DRAINAGE CERTIFICATION

TITLE: SUNDORO SOUTH SUBDIVISION UNITS 1 & 3
GRADING AND DRAINAGE PLAN
ENGINEER'S CERTIFICATION

TITLE: ENGINEER'S CERTIFICATION
SUNDORO SOUTH SUBDIVISION UNIT 2
GRADING AND DRAINAGE PLAN

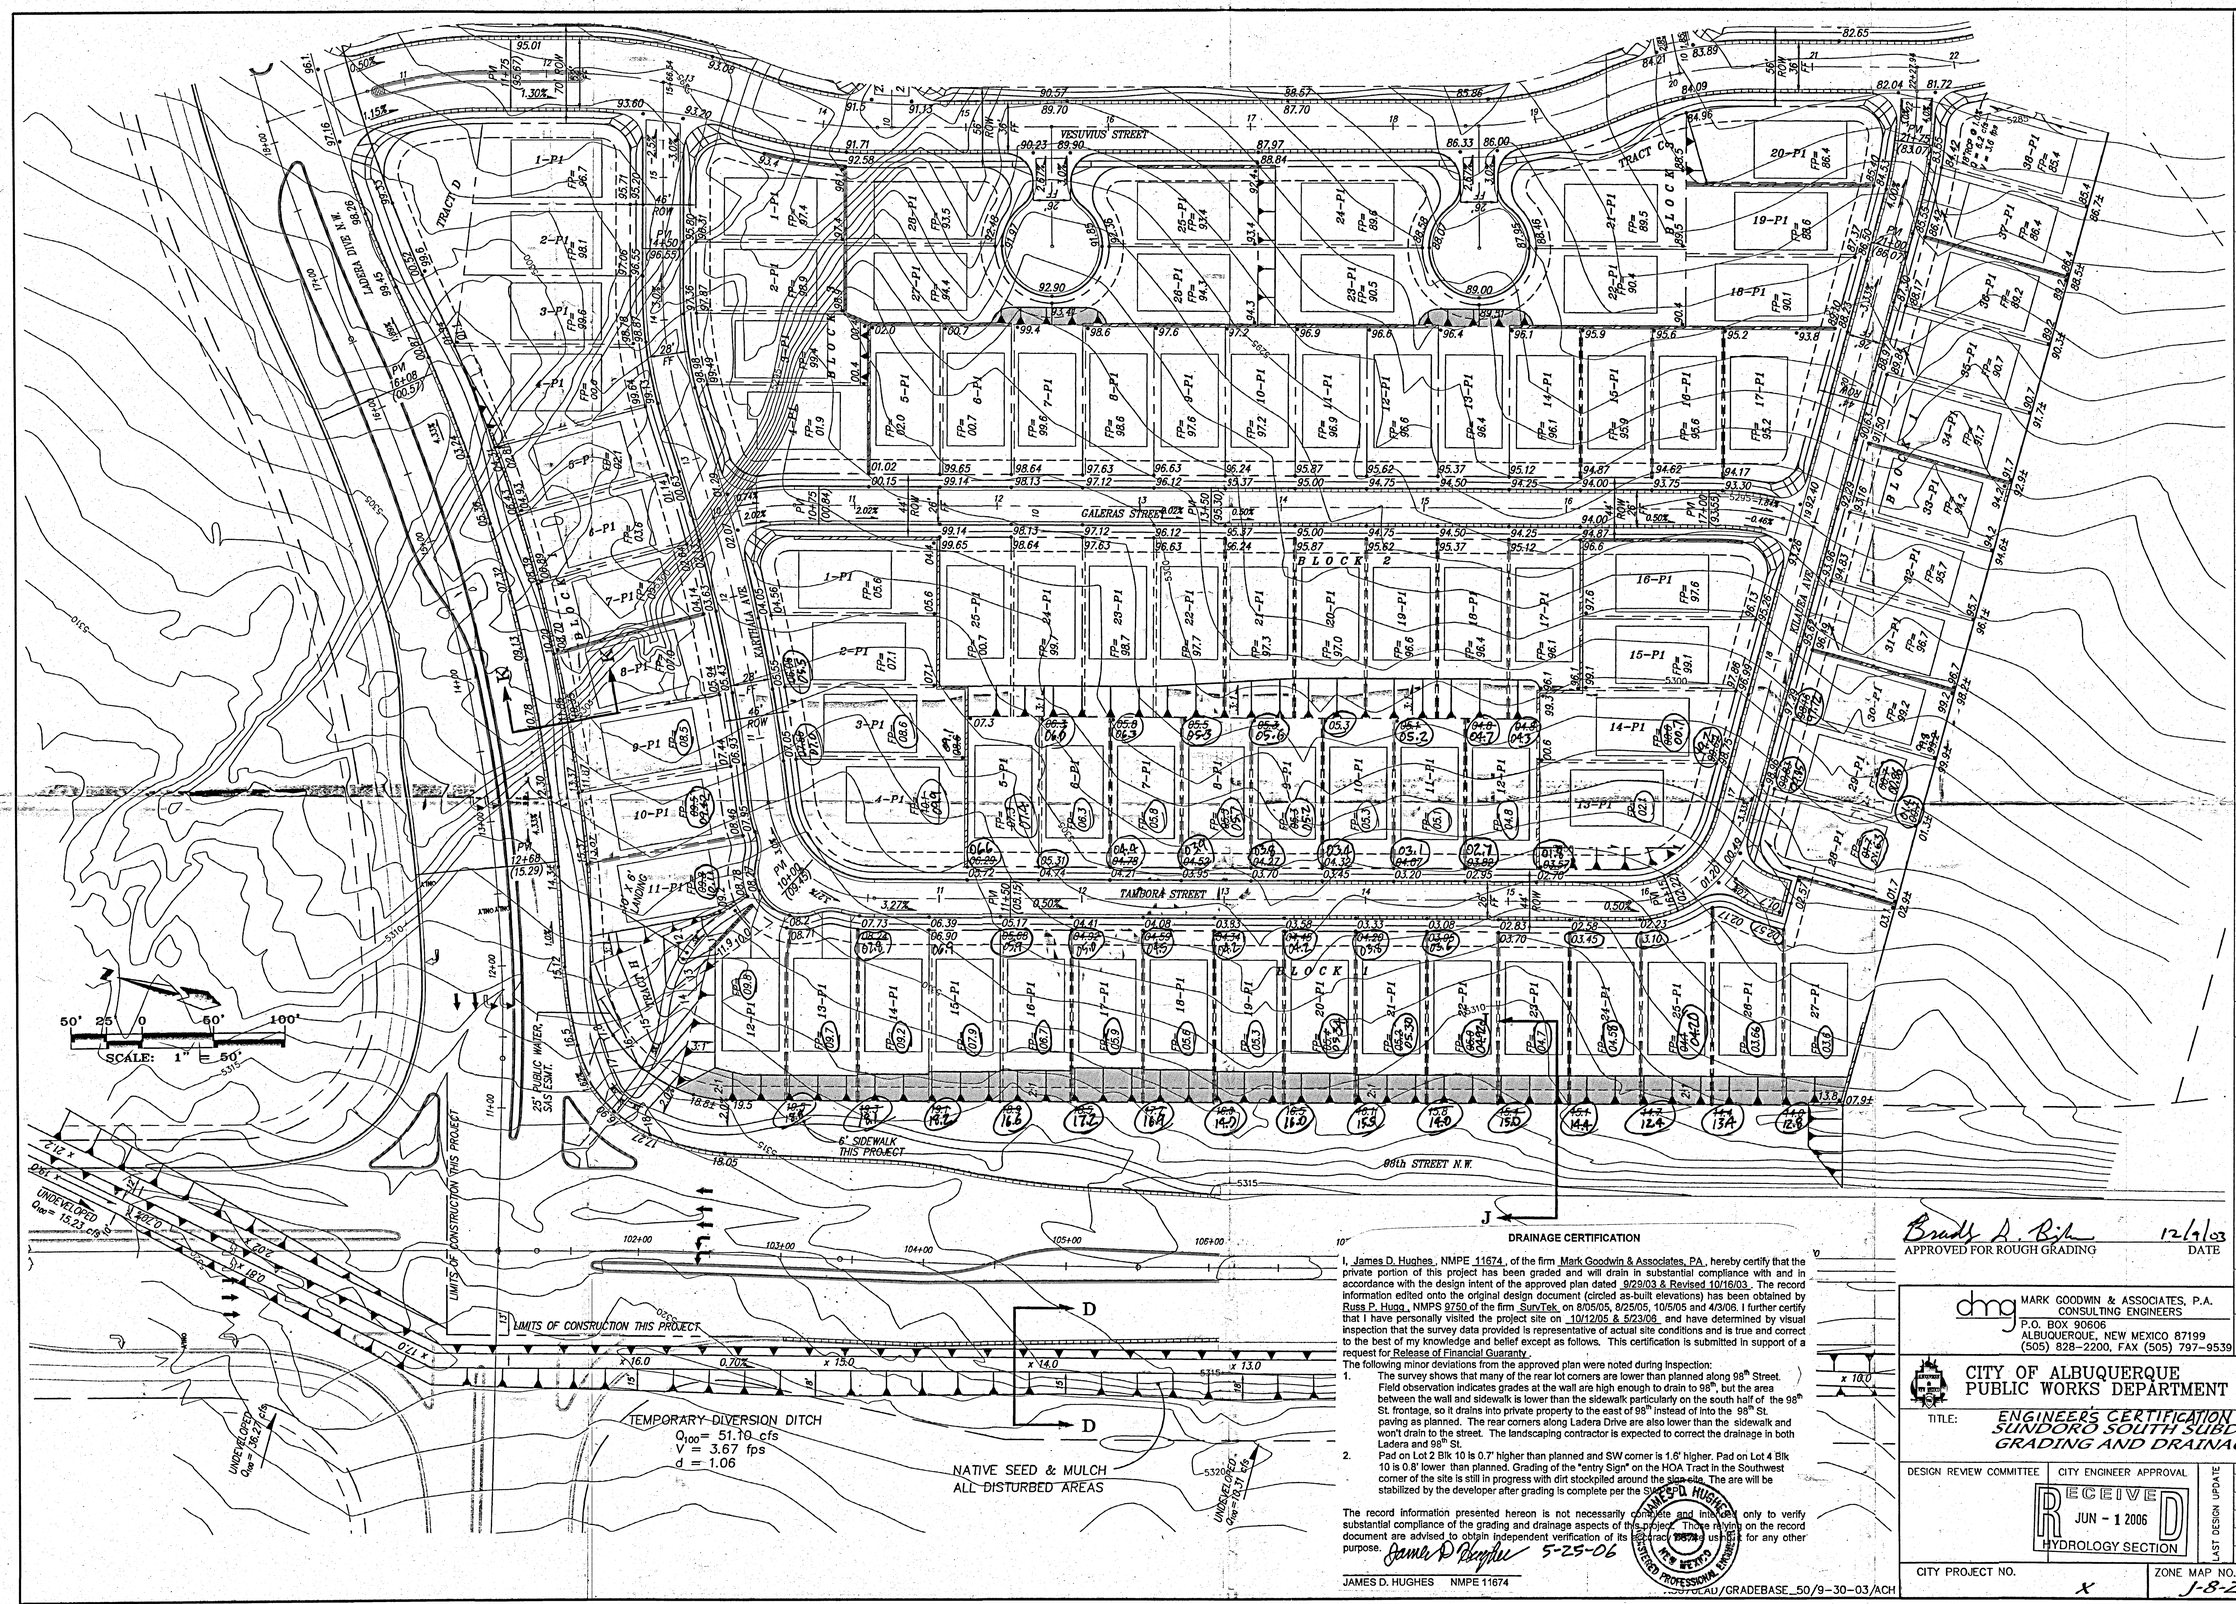
1. The survey shows that many of the rear lot corners are lower than planned along 98th Street. Field observation indicates grades at the wall are high enough to drain to 98th, but the area between the wall and sidewalk is lower than the sidewalk particularly on the south half of the 98th St. frontage, so it drains into private property to the east of 98th instead of into the 98th St. paving as planned. The rear corners along Ladera Drive are also lower than the sidewalk and won't drain to the street. The landscaping contractor is expected to correct the drainage in both Ladera and 98th St.

2. Pad on Lot 2 Blk 10 is 0.7' higher than planned and SW corner is 1.6' higher. Pad on Lot 4 Blk 10 is 0.8' lower than planned. Grading of the "entry Sign" on the HOA Tract in the Southwest corner of the site is still in progress with dirt stockpiled around the sign-site. The are will be stabilized by the developer after grading is complete per the SWPPP.
